BENDIX STREET

NON-MATERIAL AMENDMENT REPORT

D480-TGA-RP-FL_90_72-0001

16.02.23 - ISSUE 1

ELEVATIONS - BENDIX STREET

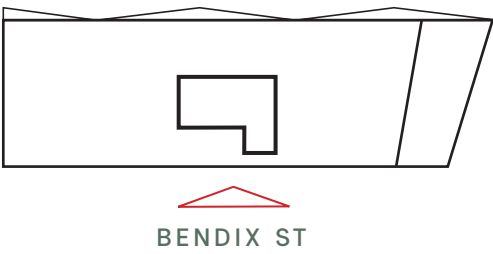
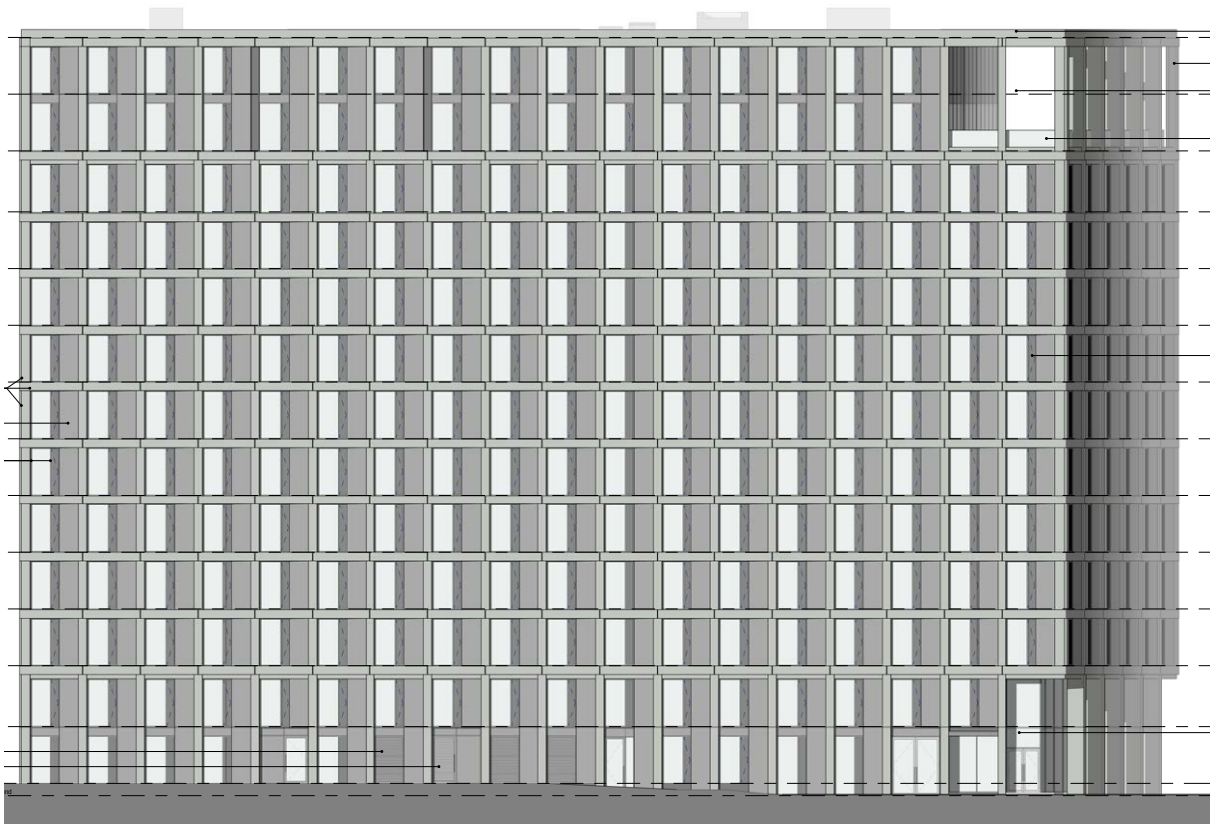
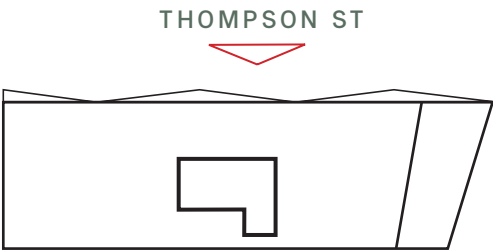
- Proposed alterations to Bendix Street elevation;
- Rooftop plant developed at detailed design
 - Window perforated pattern & soffit trim developed
 - Adjustments to ground floor access doors:
 - Commercial unit and associated access doors omitted
 - Transoms added above doors to achieve security rating
 - Additional access door (management controlled) added
 - Operational and statutory adjustments to door opening widths

ELEVATIONS - THOMPSON STREET

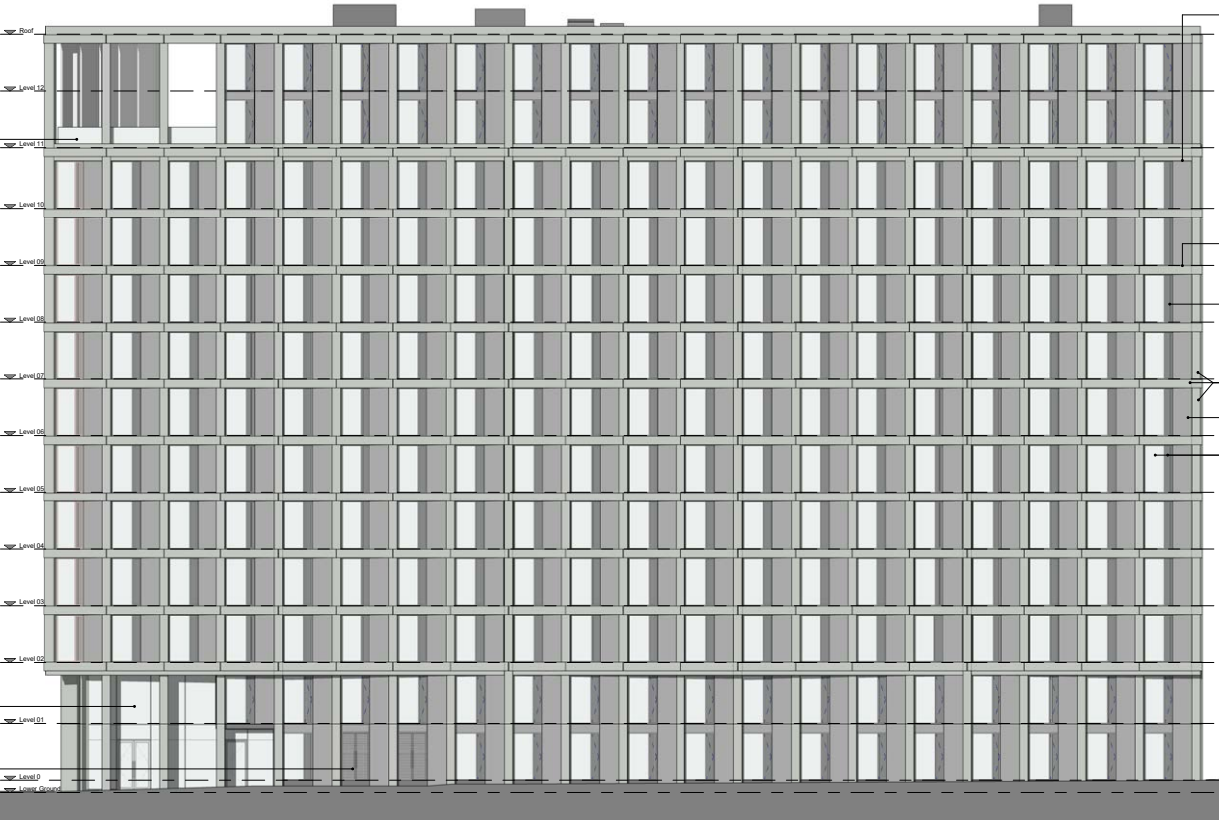
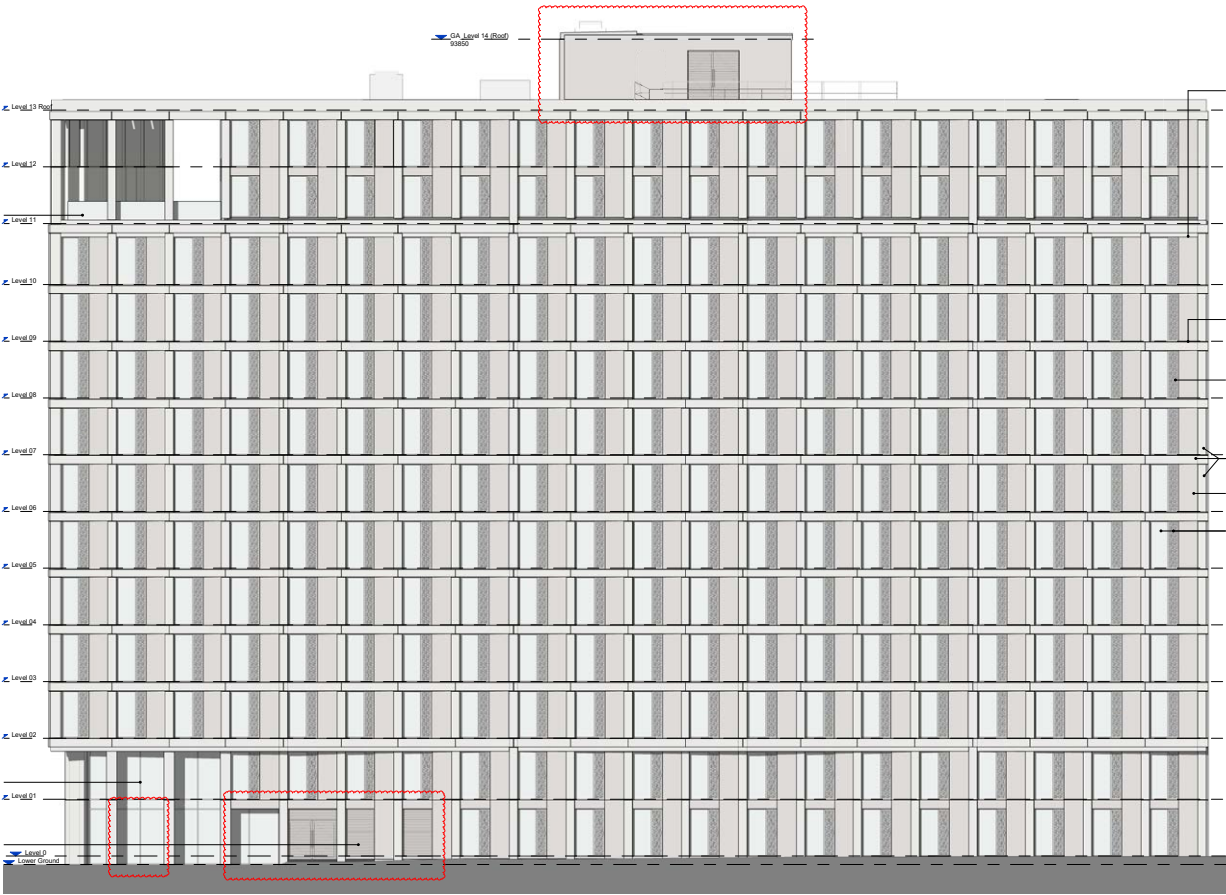
Proposed alterations to Thompson Street elevation;

- Rooftop plant developed at detailed design
- Window perforated pattern & soffit trim developed
- Adjustments to ground floor access doors:
 - Commercial unit and associated access doors omitted
 - Louvred door widened to suit Substation
 - Louvre panel and louvred door positions swapped

ELEVATIONS - NORTH-WEST BOUNDARY

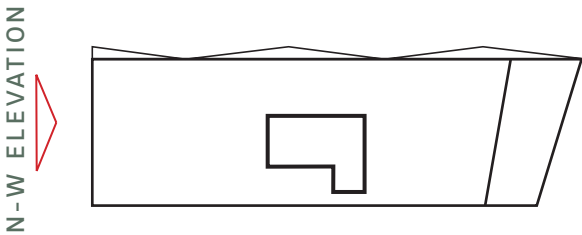
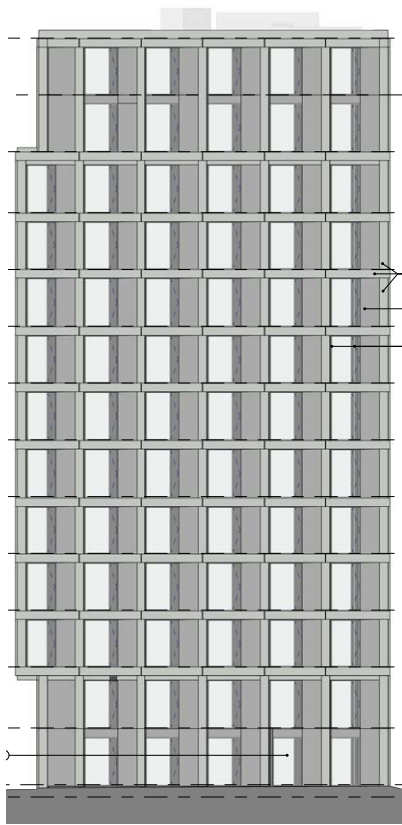
- Proposed alterations to north-west boundary elevation;
- Rooftop plant developed at detailed design
 - Window perforated pattern & soffit trim developed
